Boulder Creek Hydrologic Analysis

Phase 2: Boulder Creek above St. Vrain Creek

Prepared for
Colorado Department of Transportation

June 10, 2015

Figure ES-2 - Boulder Creek Peak Discharge Profiles

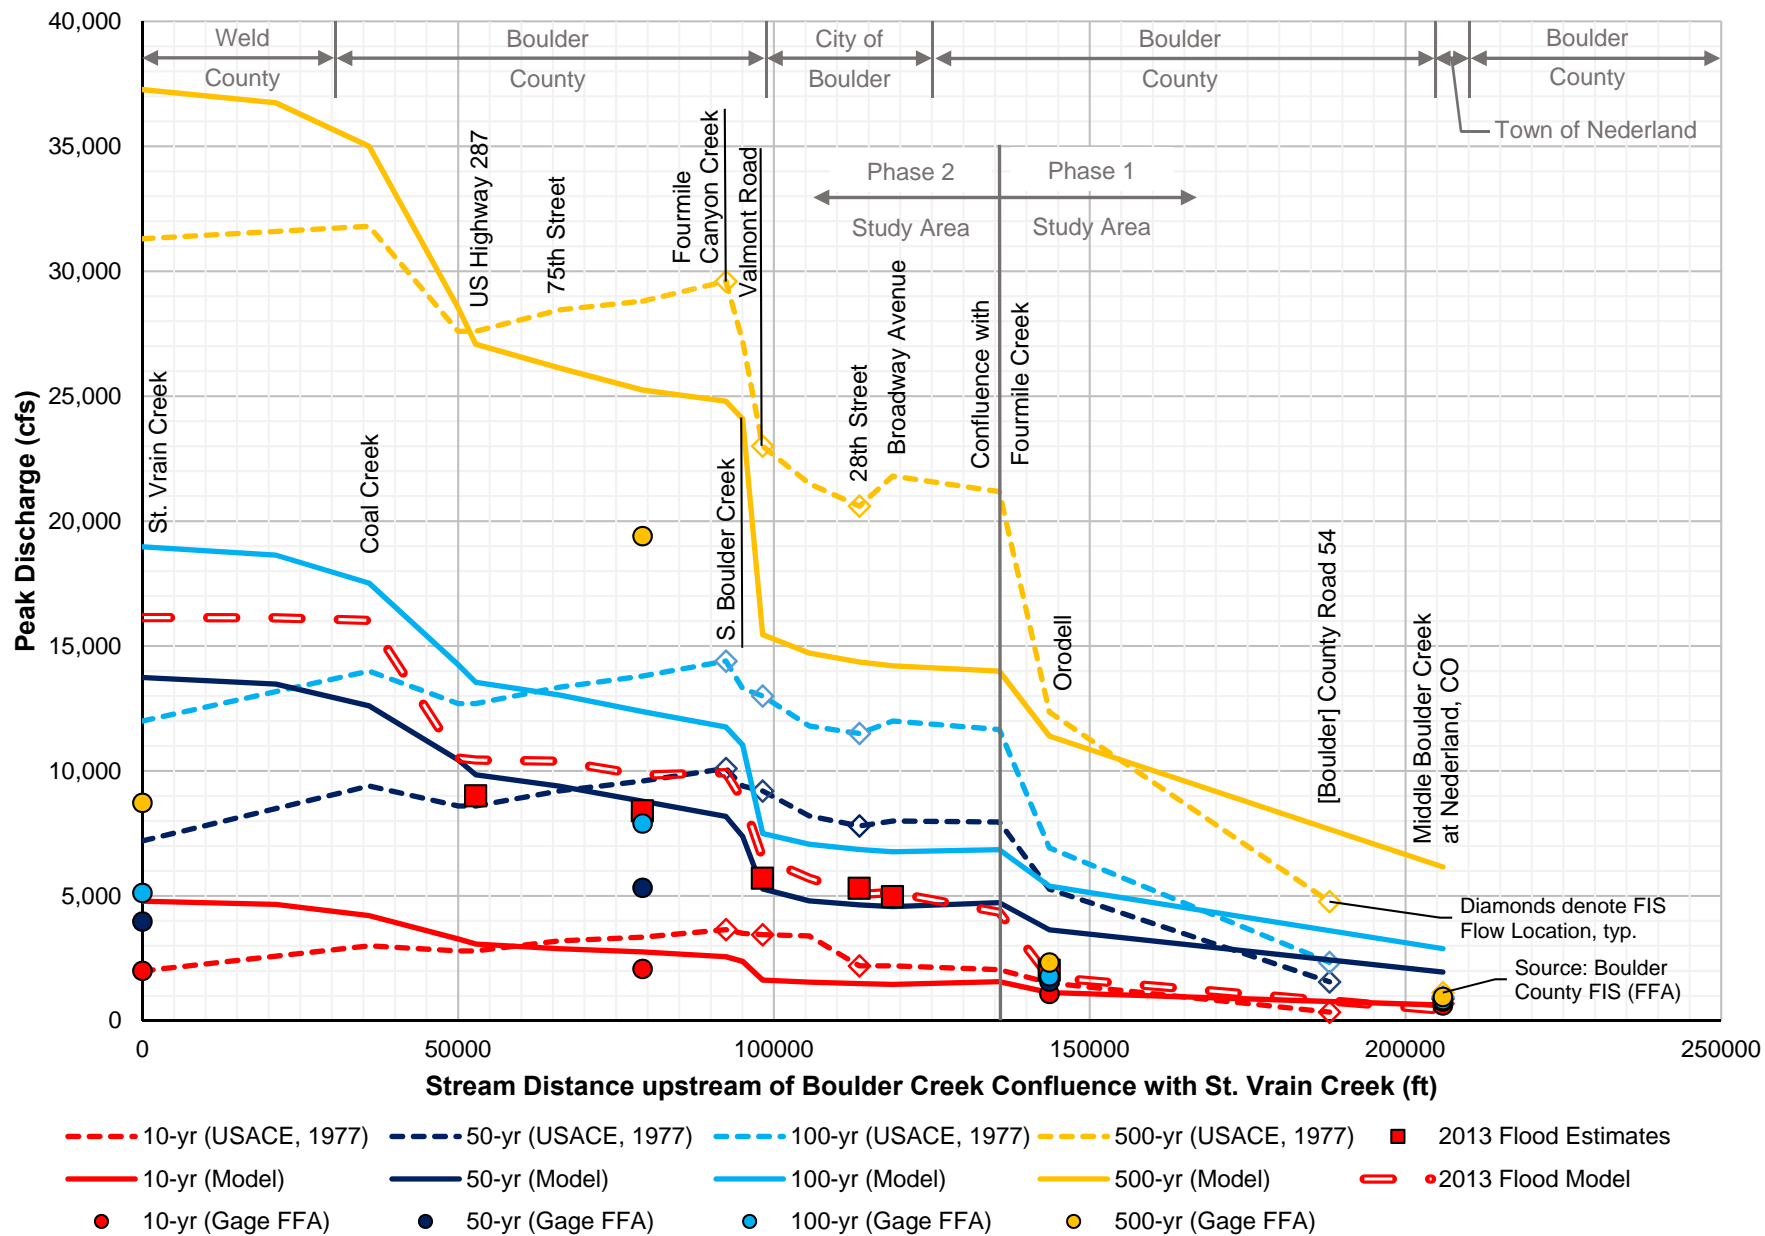
- 11. Comment:** Figure ES-2: Flipping the x axis to show distance downstream of initial estimate makes more sense.

FIGURE 3a
September 2013 Flood Extents in the City of Boulder and
Assessment of Urban Stream Conditions
 CDOT Flood Recovery Hydrologic Evaluation
 Source: City of Boulder, 2013b

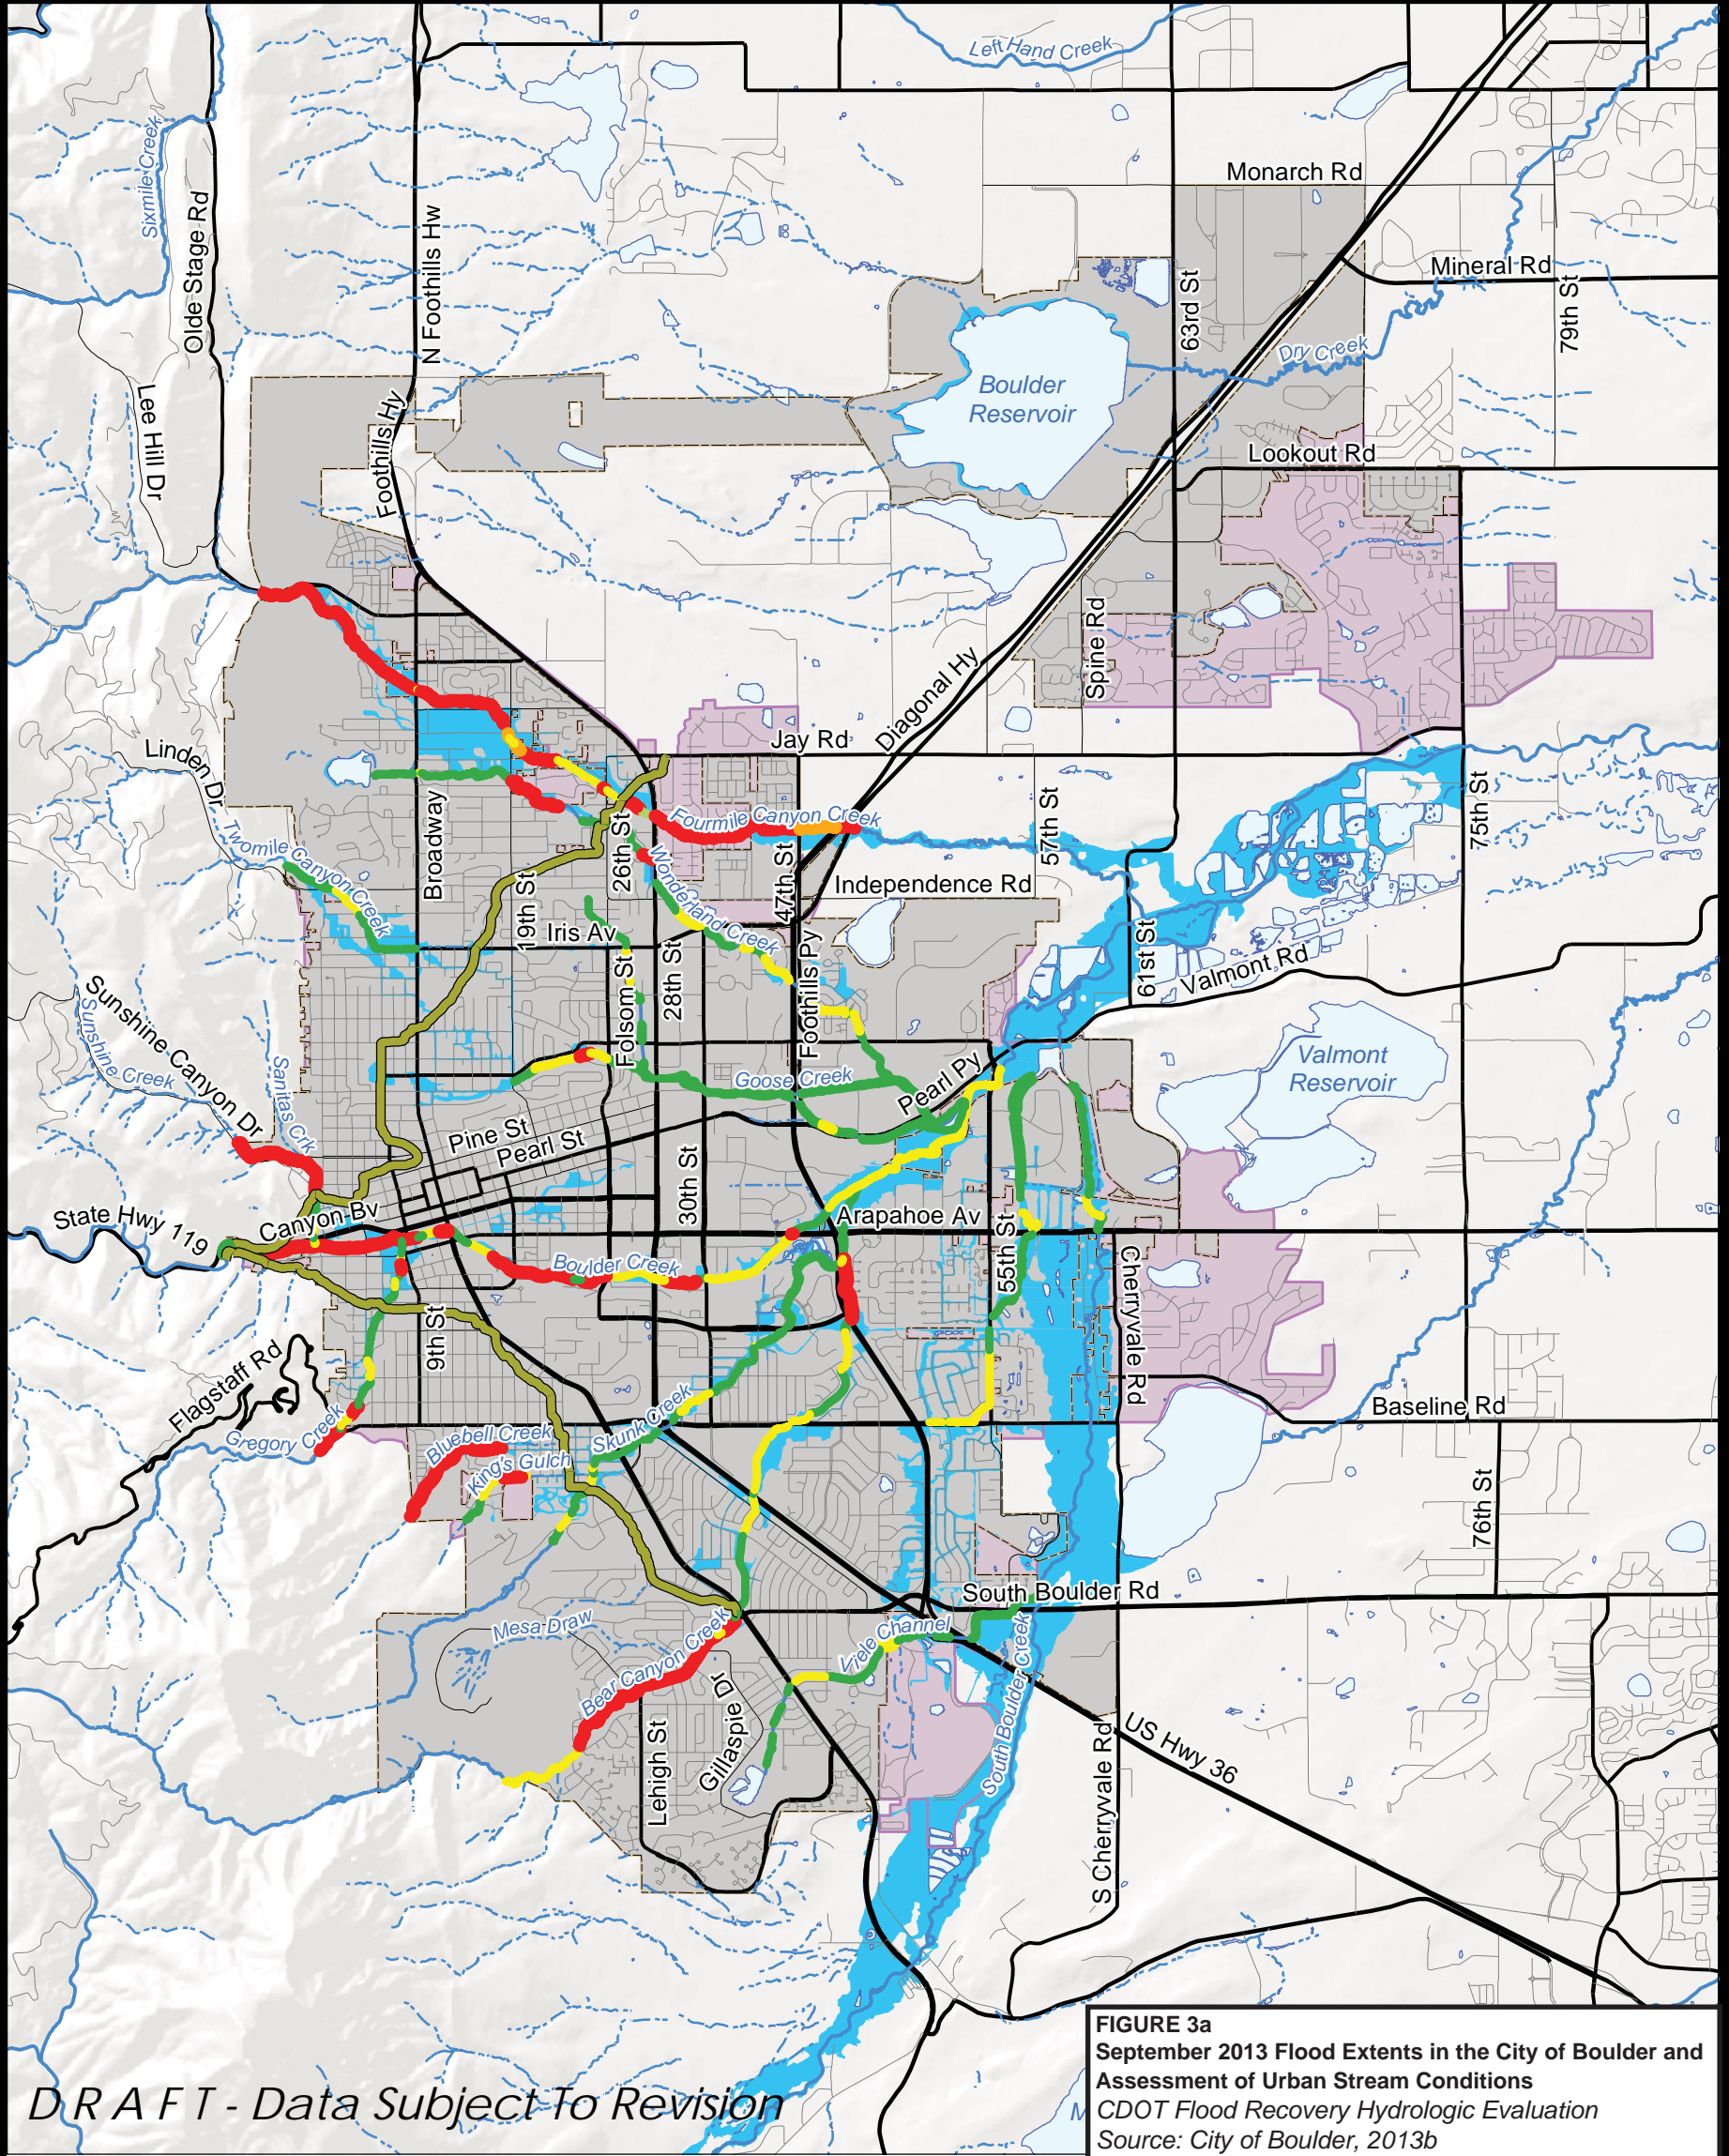
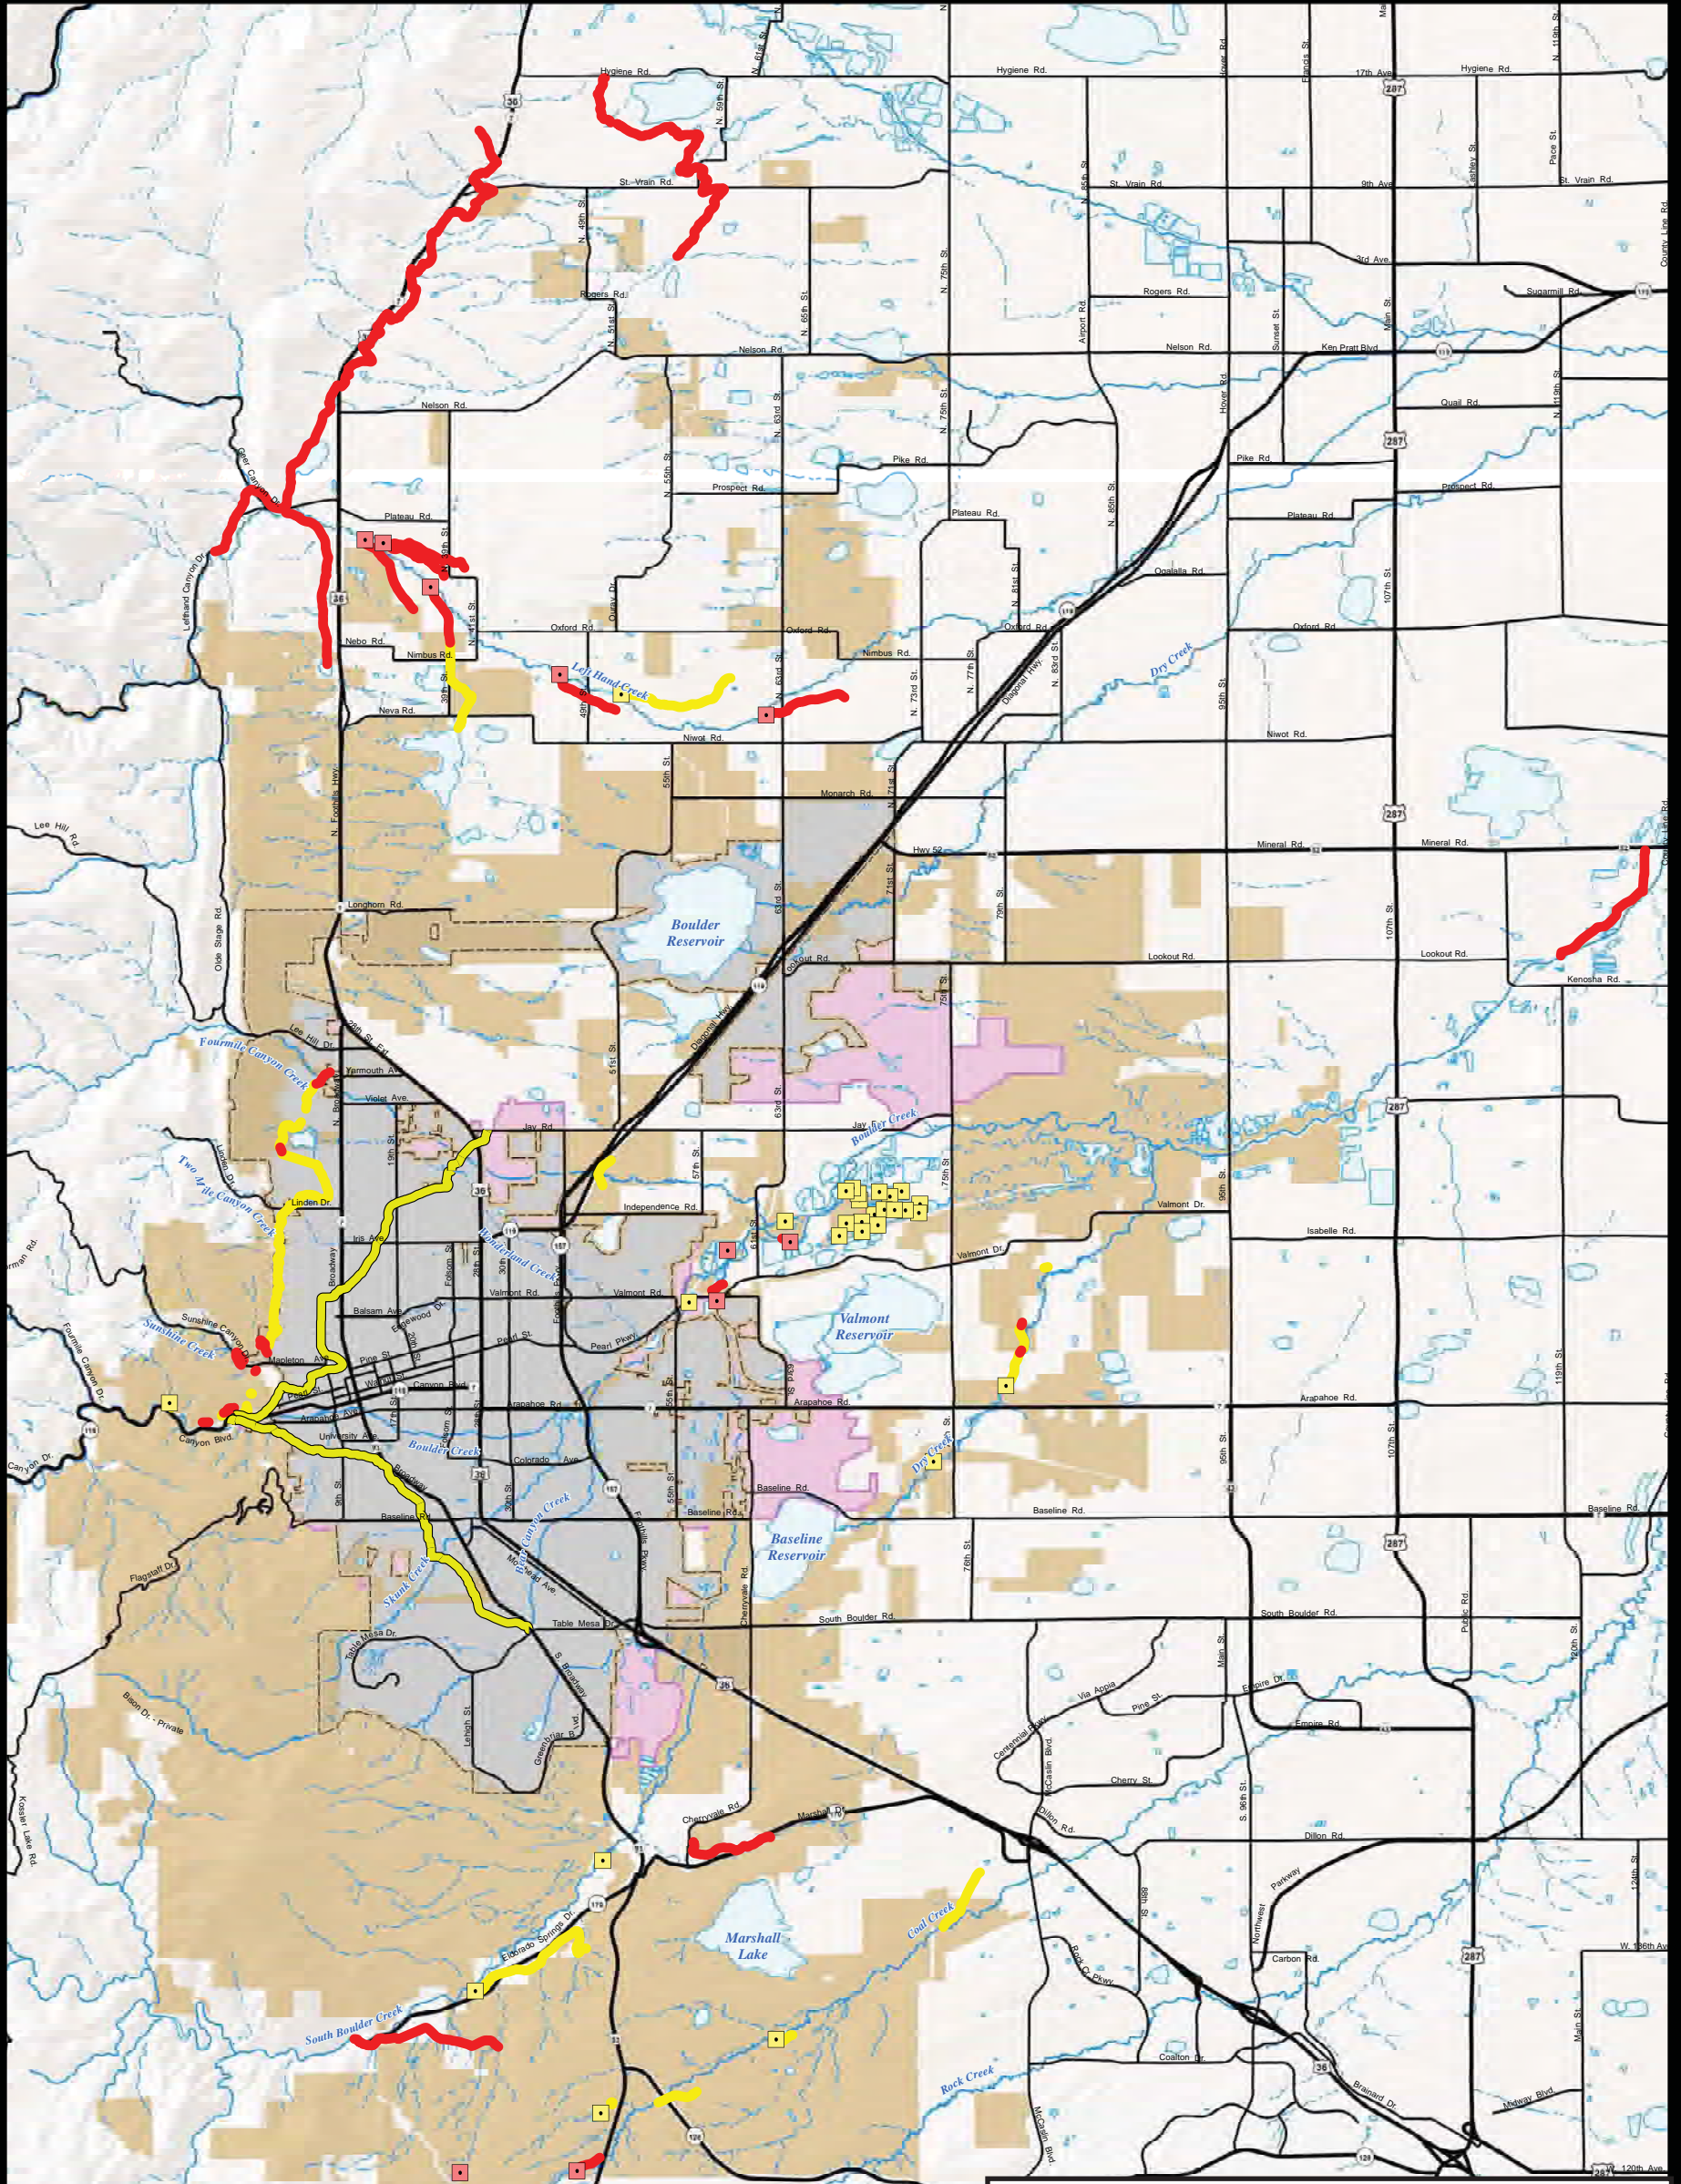
- 19. Comment:** Section 2.4.4 Basin Characterization – might be a good place to reference Figure 3 A & B which are maps showing the urban stream and ditch conditions, and OSMP ditch/headgate/dam damage assessments. These figures are not mentioned anywhere else in the report.

Response: *References to Figure 3a and Figure 3b have been added to Section 1.6.2.*
